PROJECT REFERENCE NO. R-2610 B	SHEET NO. EC-11/CONST.12
R/W SHEET NO.	
ROADWAY DESIGN ENGINEER	HYDRAULICS ENGINEER
CONST. REV.	
R/W REV.

**CLEARING AND GRUBBING
EROSION CONTROL FOR
CONSTRUCTION SHEET 12**

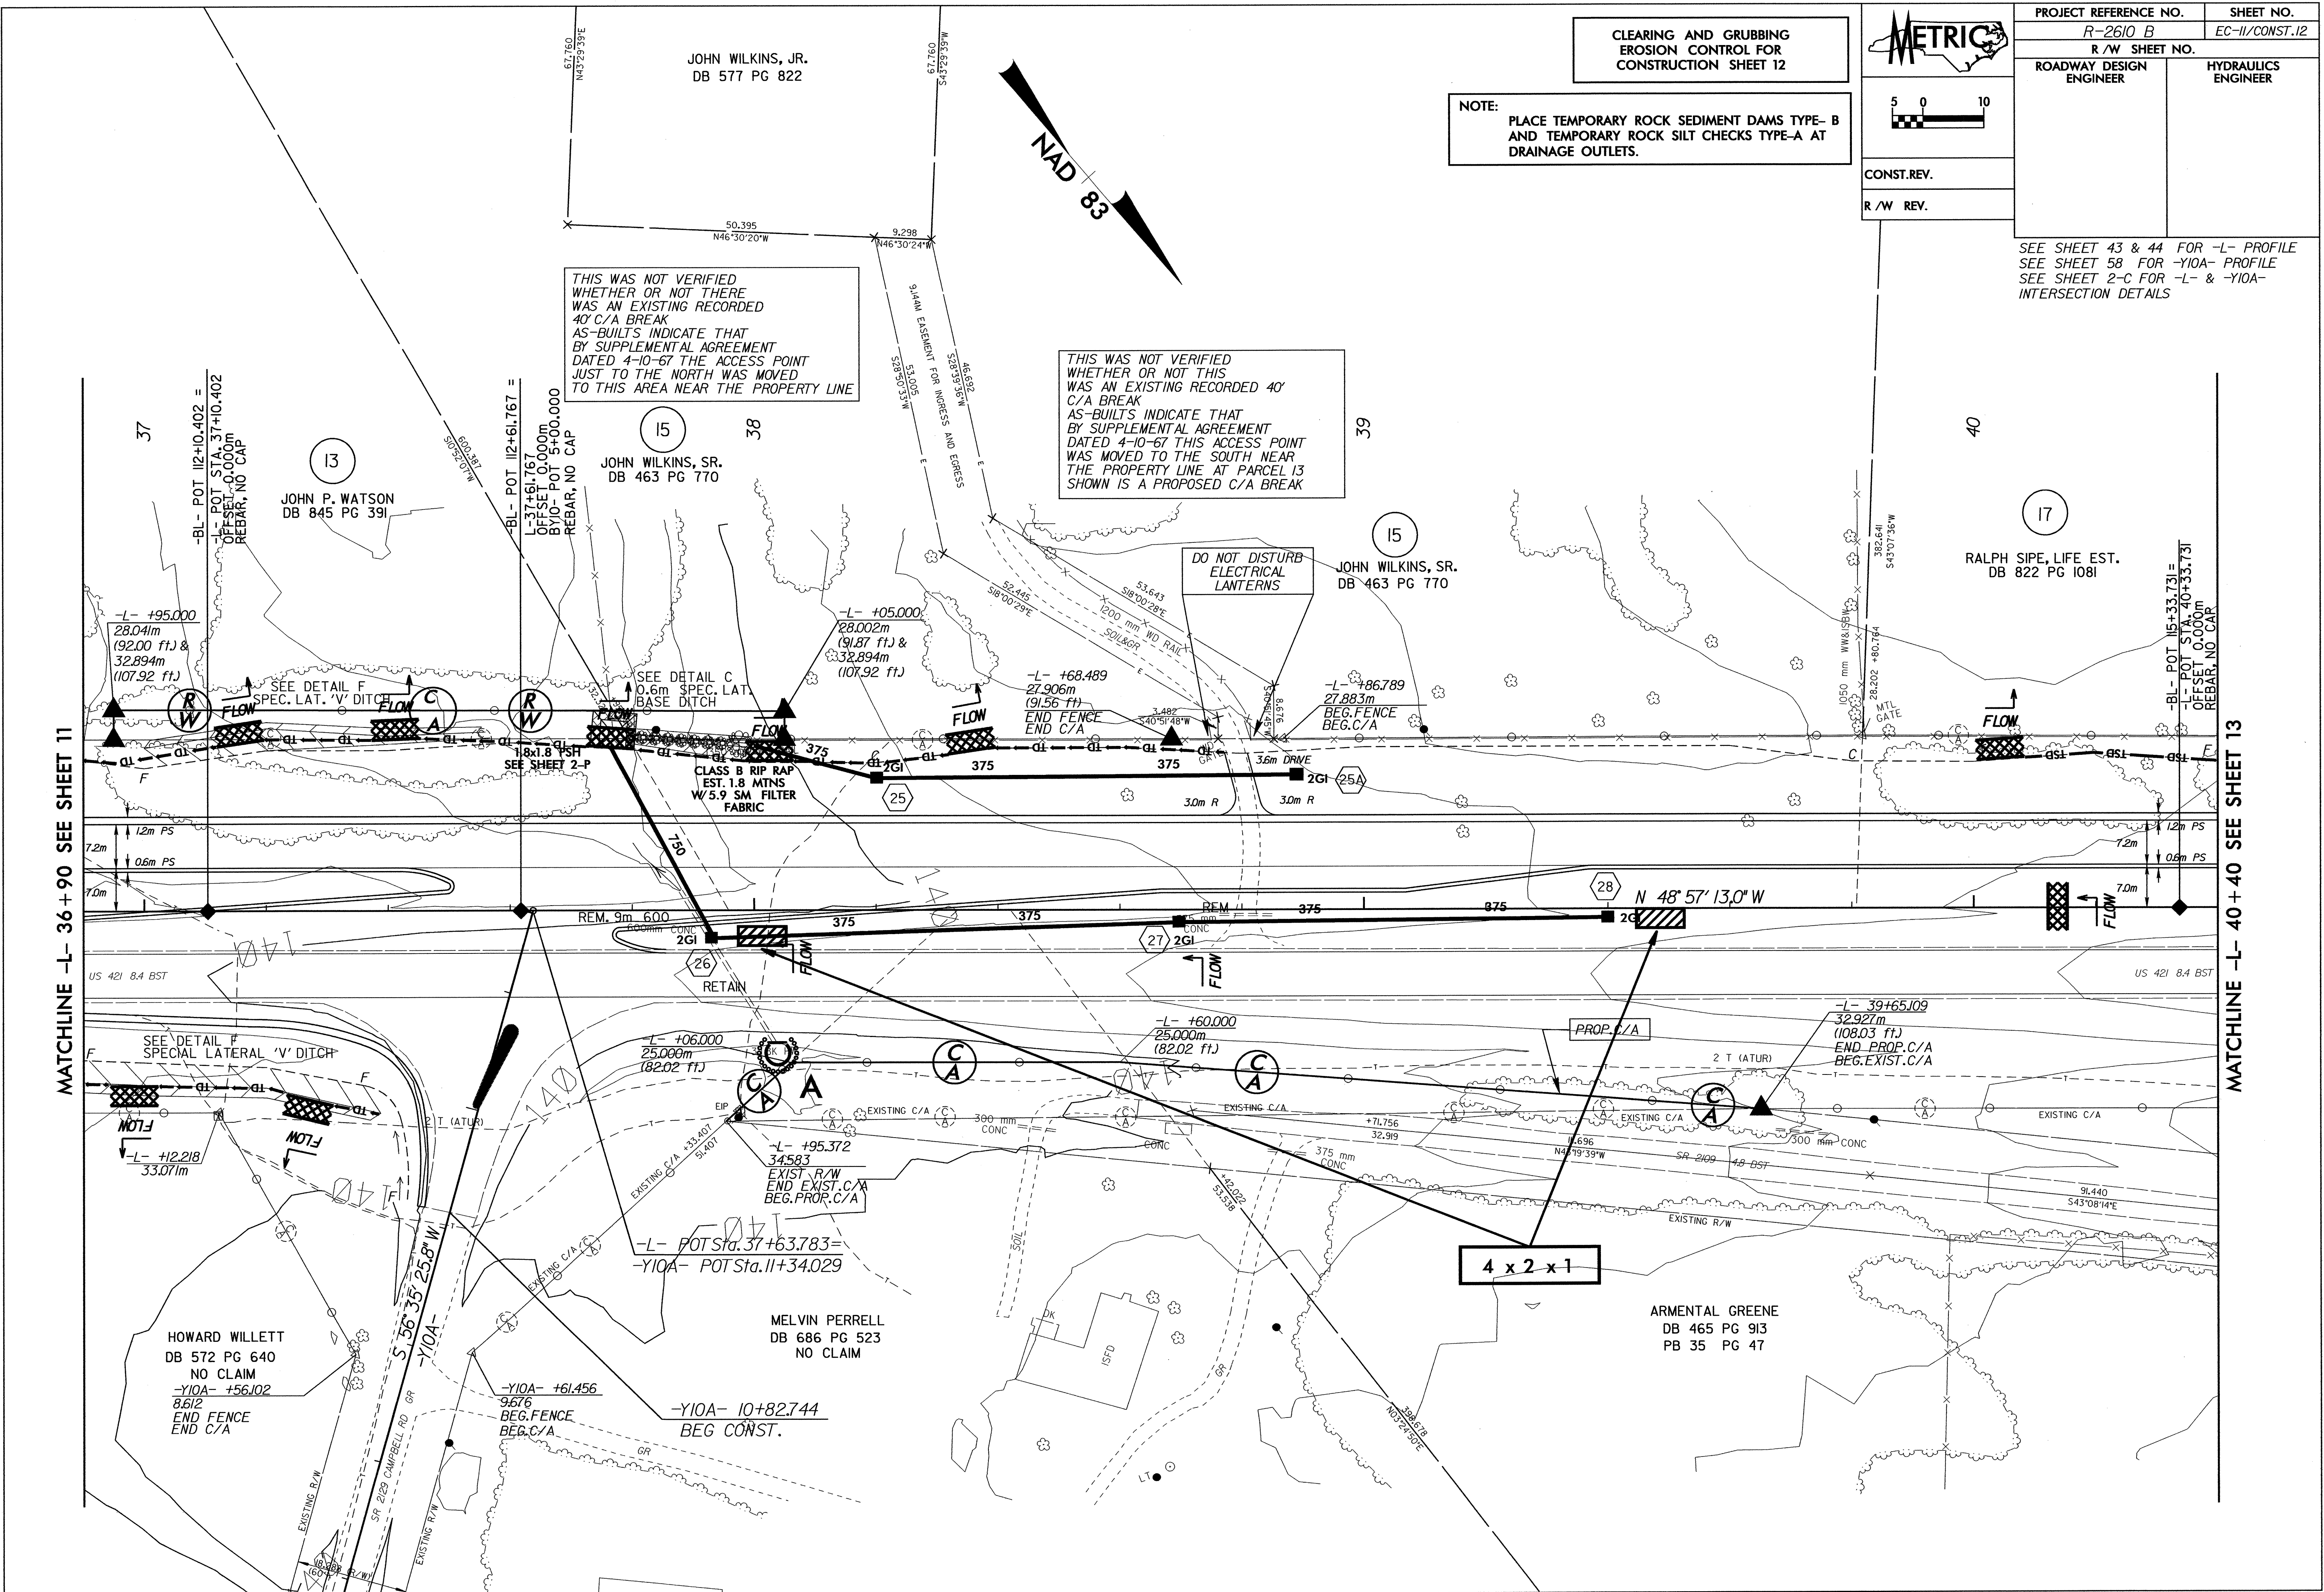
THIS WAS NOT VERIFIED
WHETHER OR NOT THERE
WAS AN EXISTING RECORDED
40' C/A BREAK
AS-BUILTS INDICATE THAT
BY SUPPLEMENTAL AGREEMENT
DATED 4-10-67 THE ACCESS POINT
JUST TO THE NORTH WAS MOVED
TO THIS AREA NEAR THE PROPERTY LINE

THIS WAS NOT VERIFIED
WHETHER OR NOT THIS
WAS AN EXISTING RECORDED 40'
C/A BREAK
AS-BUILTS INDICATE THAT
BY SUPPLEMENTAL AGREEMENT
DATED 4-10-67 THIS ACCESS POINT
WAS MOVED TO THE SOUTH NEAR
THE PROPERTY LINE AT PARCEL 13
SHOWN IS A PROPOSED C/A BREAK

DO NOT DISTURB
ELECTRICAL
LANTERNS
